The Victoria Project, Sri Lanka

Project planning, design and construction of Victoria Dam; construction of Victoria Tunnel; Victoria Power-Station

P. A. A. Back, W. T. Mee, K. L. Cole, P. C. Neal, A. J. H. Speirs,
P. J. Chapman and B. Creber*

Fig. 1. Cut configurations used in Dinorwig Power Station excavation

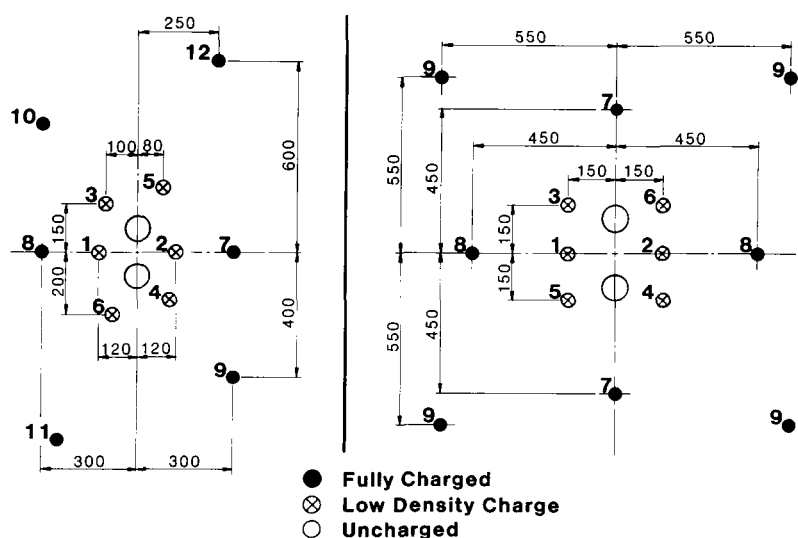
48. While Dinorwig was largely excavated in hard slate, the 'spiral' cuts proved successful in the extremely hard gritstones and dolerites. However, great care had to be taken to ensure that all holes in the cut were collared accurately and then drilled parallel to each

Fig. 3. Time-distance chart: surge chamber and tunnel

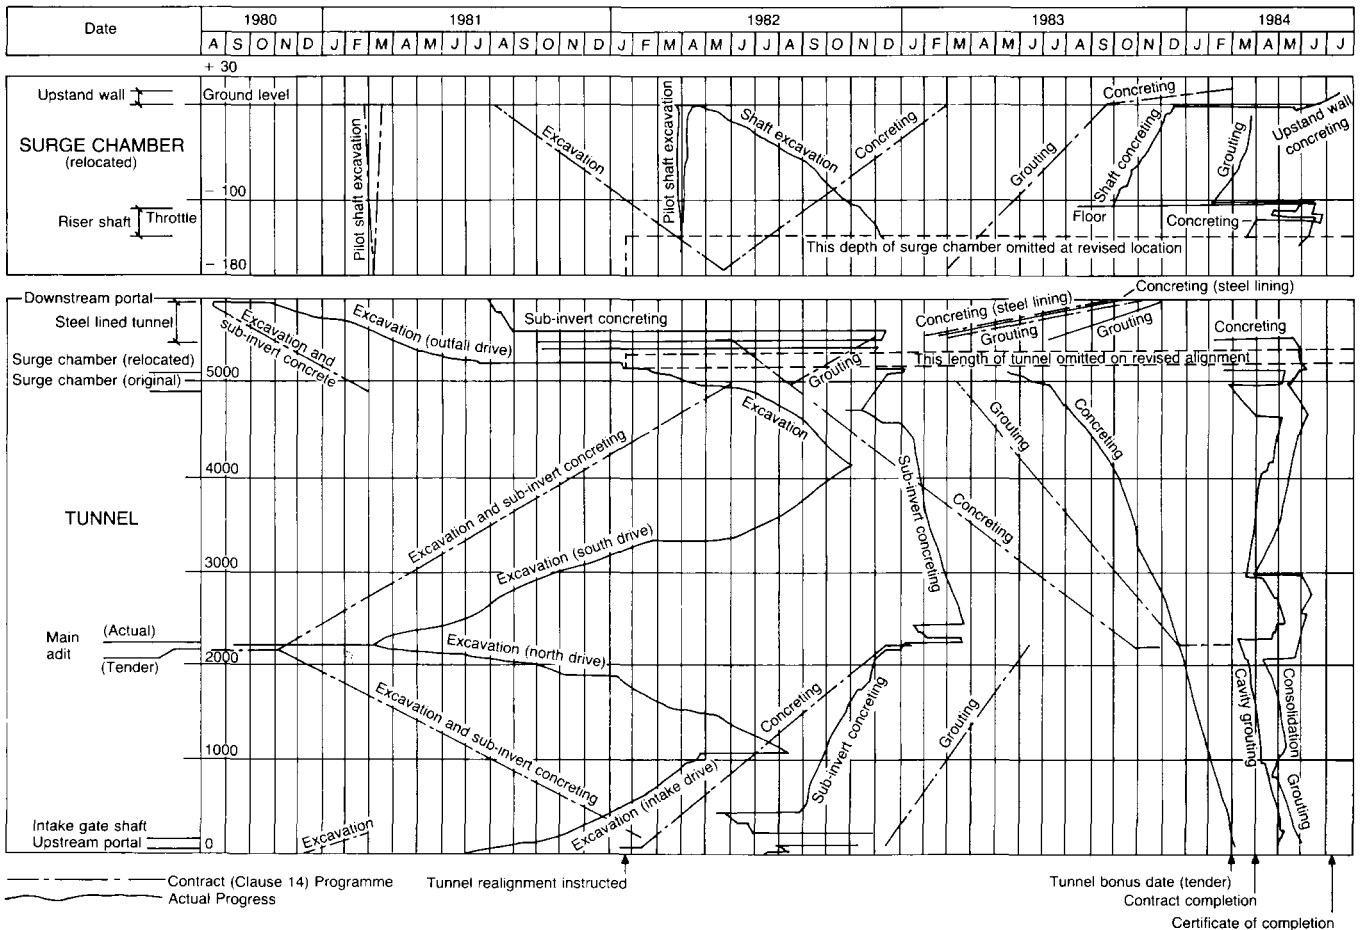
58. All concerned with the Victoria Tunnel are to be congratulated on the reduction in the overrun on completion from 15 months to about three months, and, in particular, on achieving high rates of progress with concreting and grouting the tunnel. Could the Authors indicate on a progress chart the rates of progress of the works at the different faces?

63. Could the Authors indicate the rates of progress of the works at the different faces on a progress chart given in Fig. 2?

131. With regard to the question in § 58, a progress chart is given in Fig. 3.

136. The answer to the question in § 63 is also given in Fig. 3.
